STATE OF MAINE
DEPARTMENT OF TRANSPORTATION
16 STATE HOUSE STATION
AUGUSTA, MAINE 04333-0016

January 9, 2018
Subject: Auxiliary Turning Lanes &
Bernard Lown Peace Bridge
Rehabilitation
State WINs: 018650.00 & 022599.00
Location: **Lewiston & Auburn**
Amendment No. 1

BERNARD LOWN PEACE BRIDGE
ANDROSCOGGIN RIVER
AUBURN-LEWISTON ANDROSCOGGIN CO.
PIER 1 REPAIR DETAILS

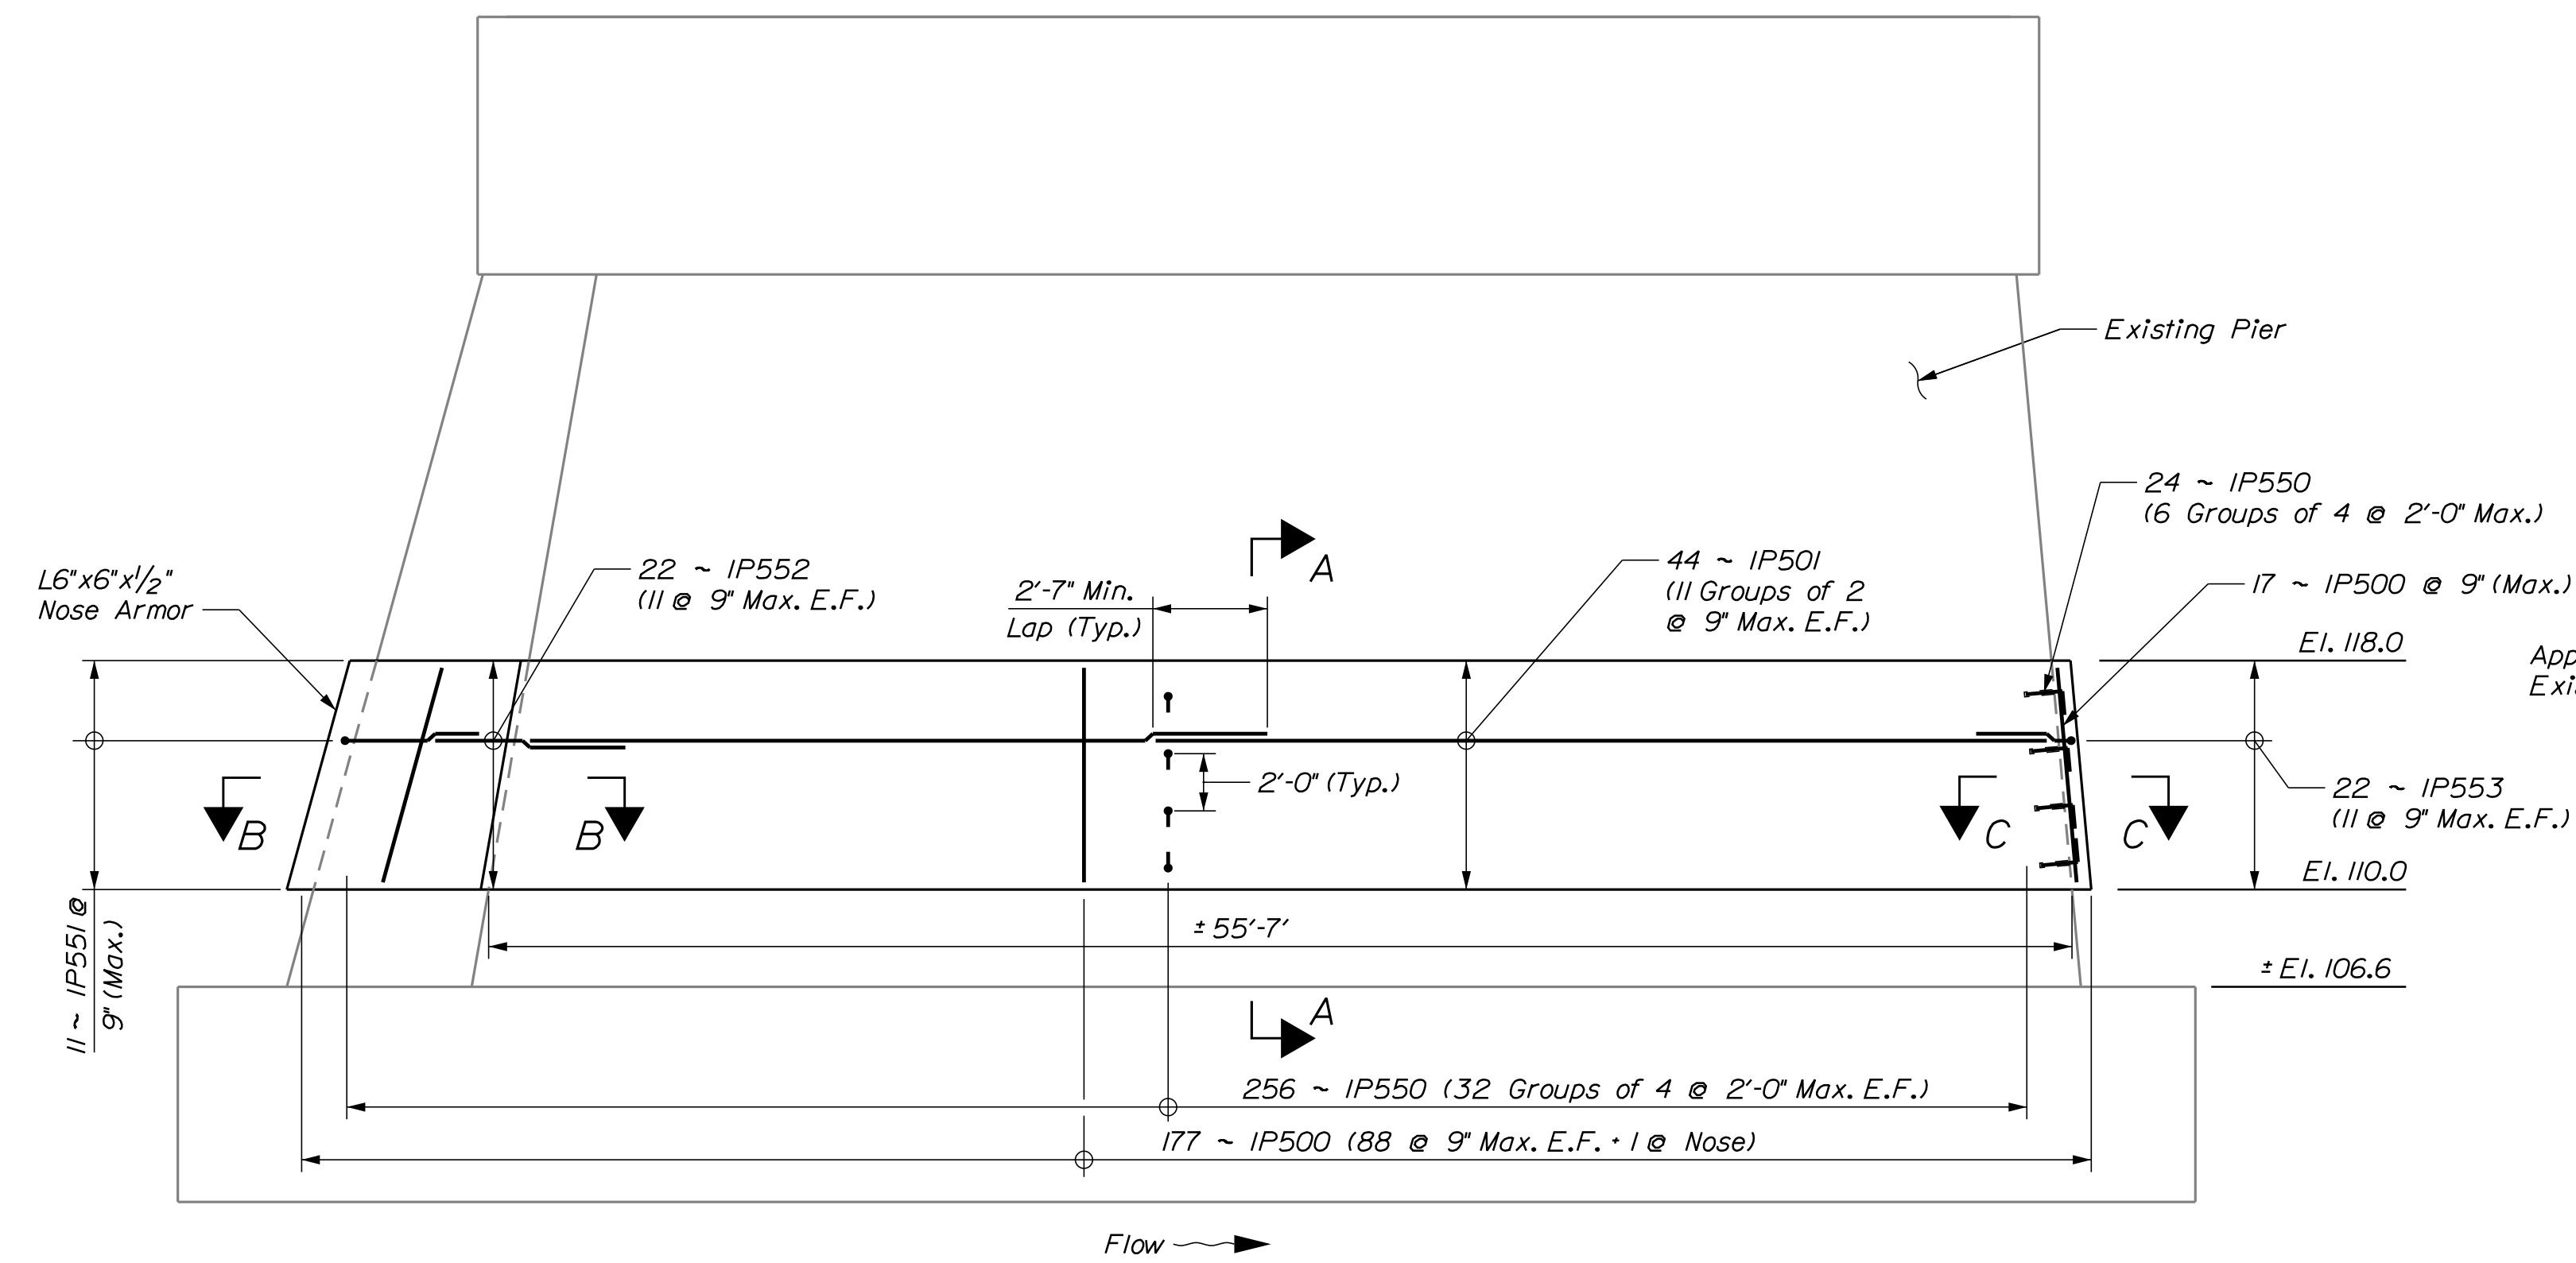
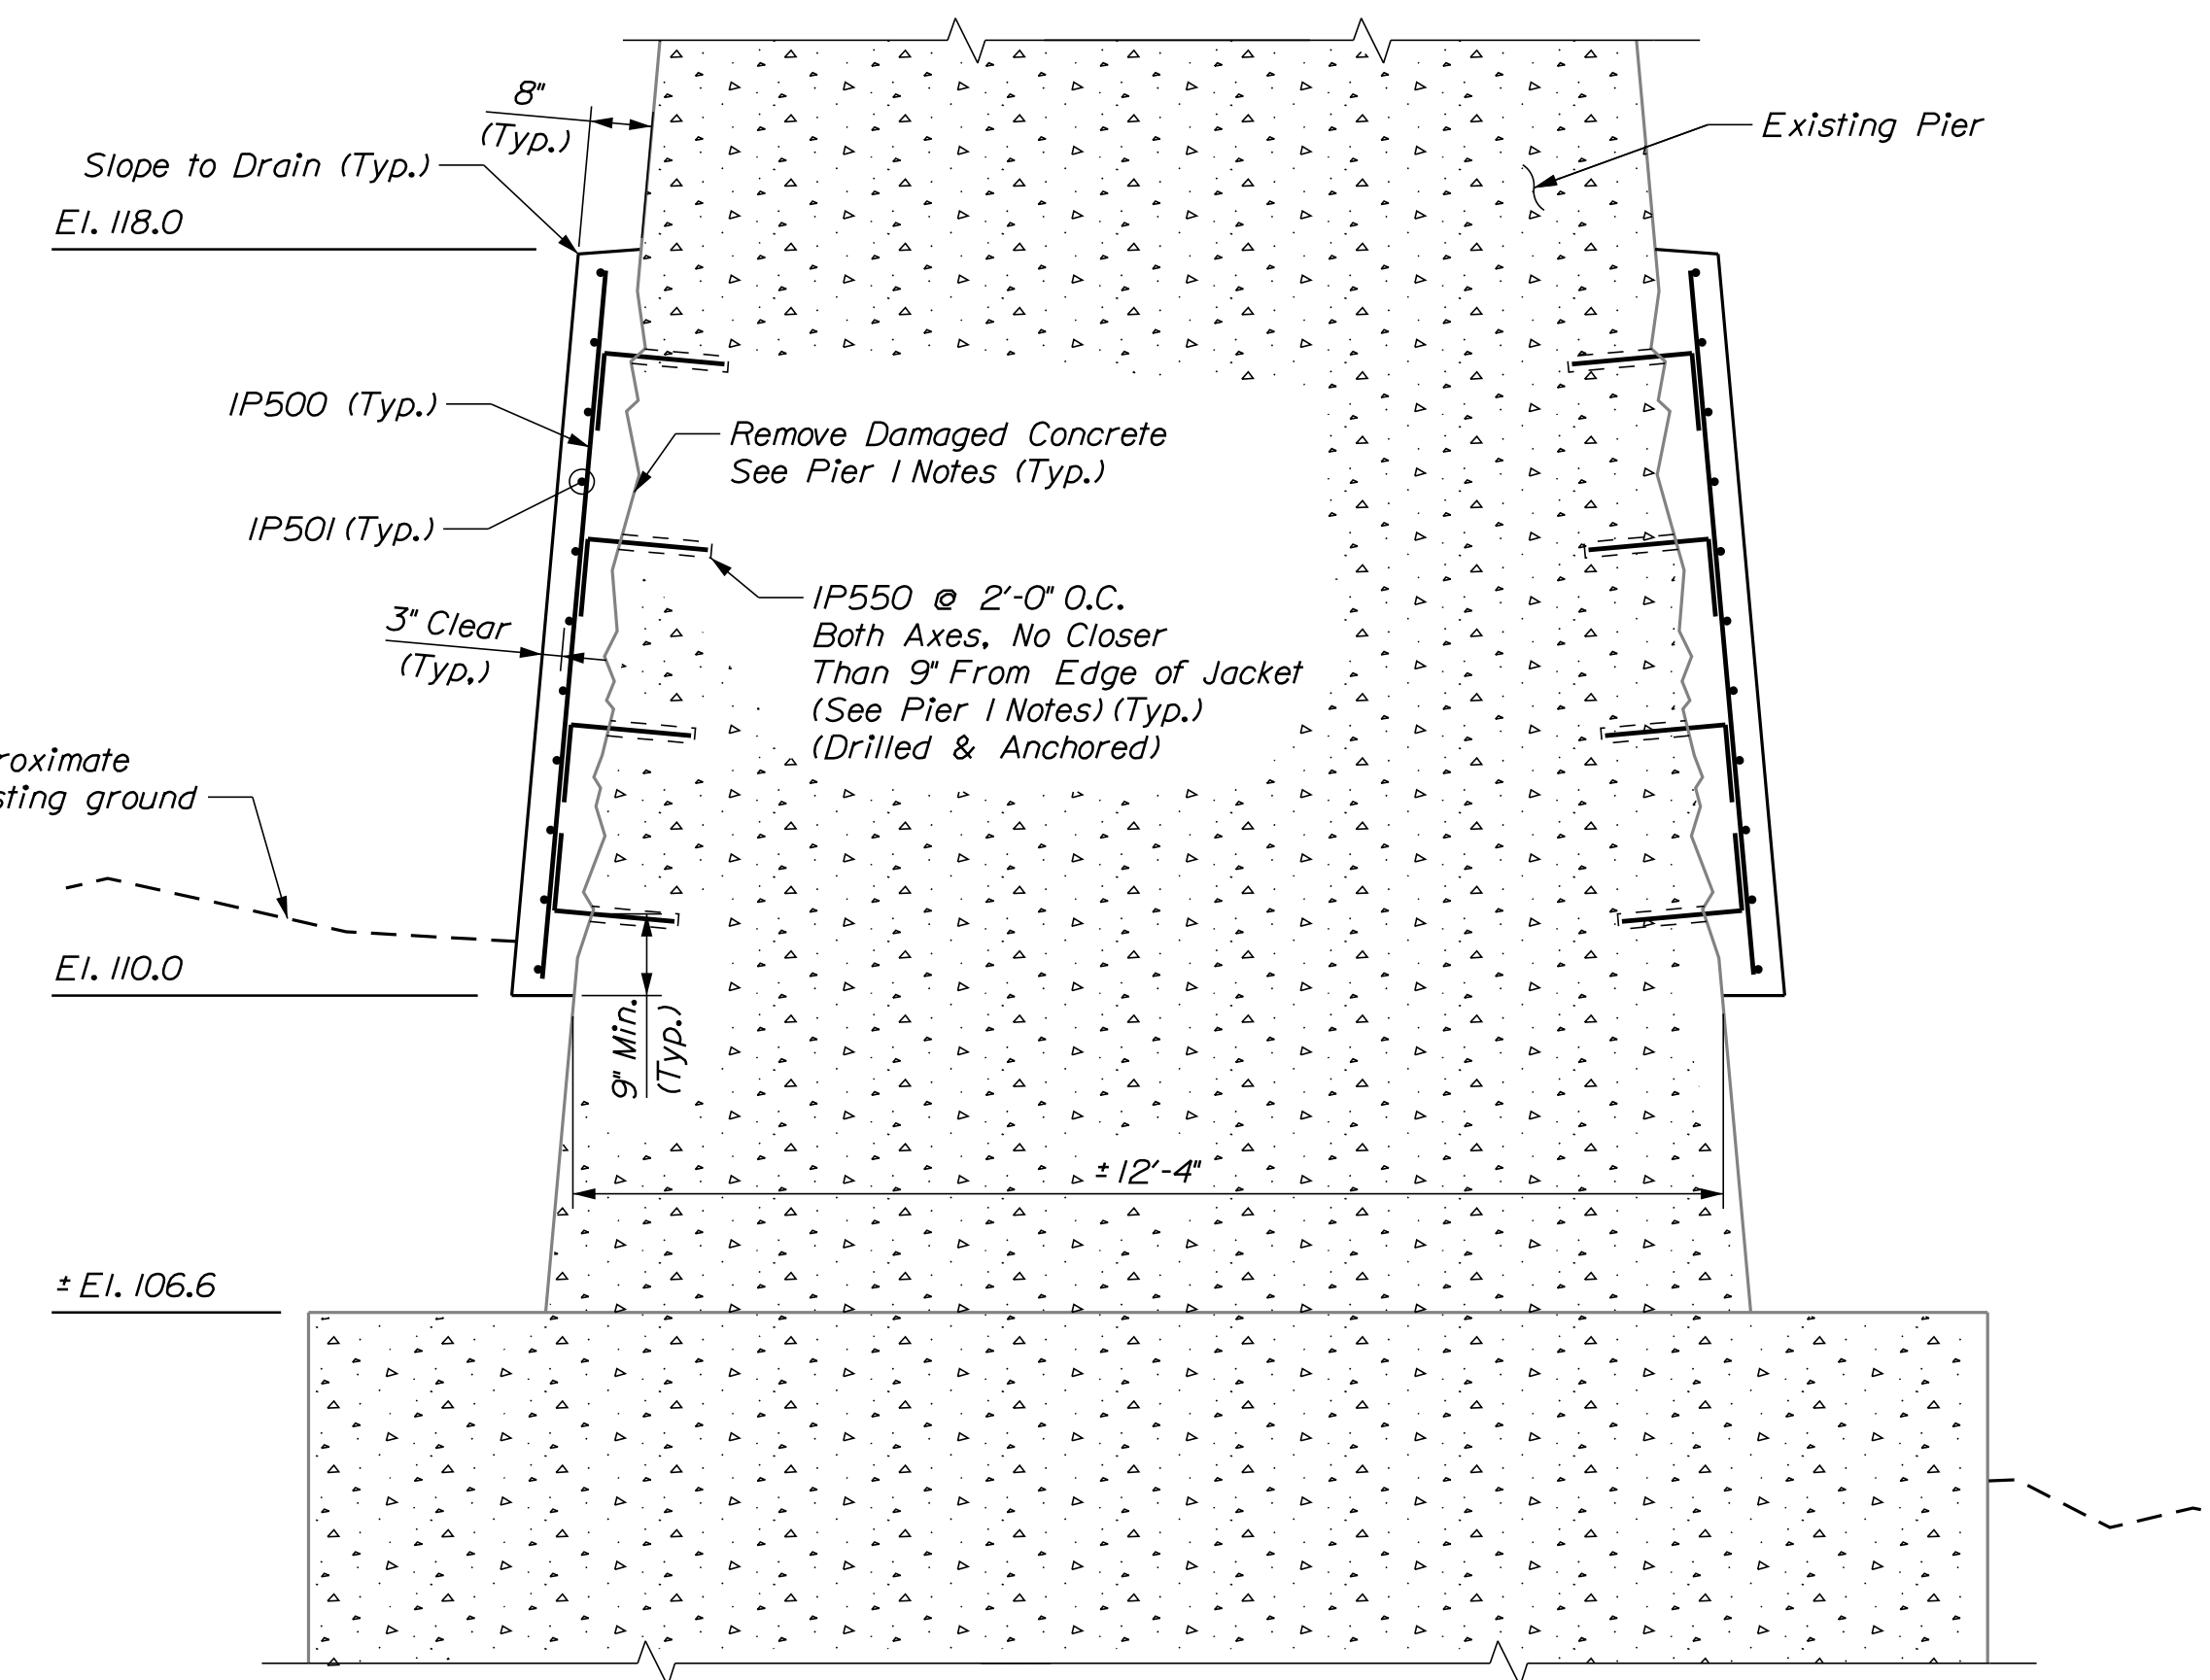
REMOVE SHEET NUMBER 10 OF 20, PIER 1 REPAIR DETAILS, and **REPLACE** with the attached, revised SHEET NUMBER 10 OF 20, PIER 1 REPAIR DETAILS.

Question: How will pier excavation be paid for at Pier No. 1?

Response: Any excavation and disposal of material necessary at Pier No. 1 shall be incidental to the Cofferdam item. A plan note will be added to clarify this.

7. Excavation and disposal of soil shall be considered incidental to Item 511.07, "Cofferdam" and shall be performed in accordance with the requirements of Standard Specification Section 203.
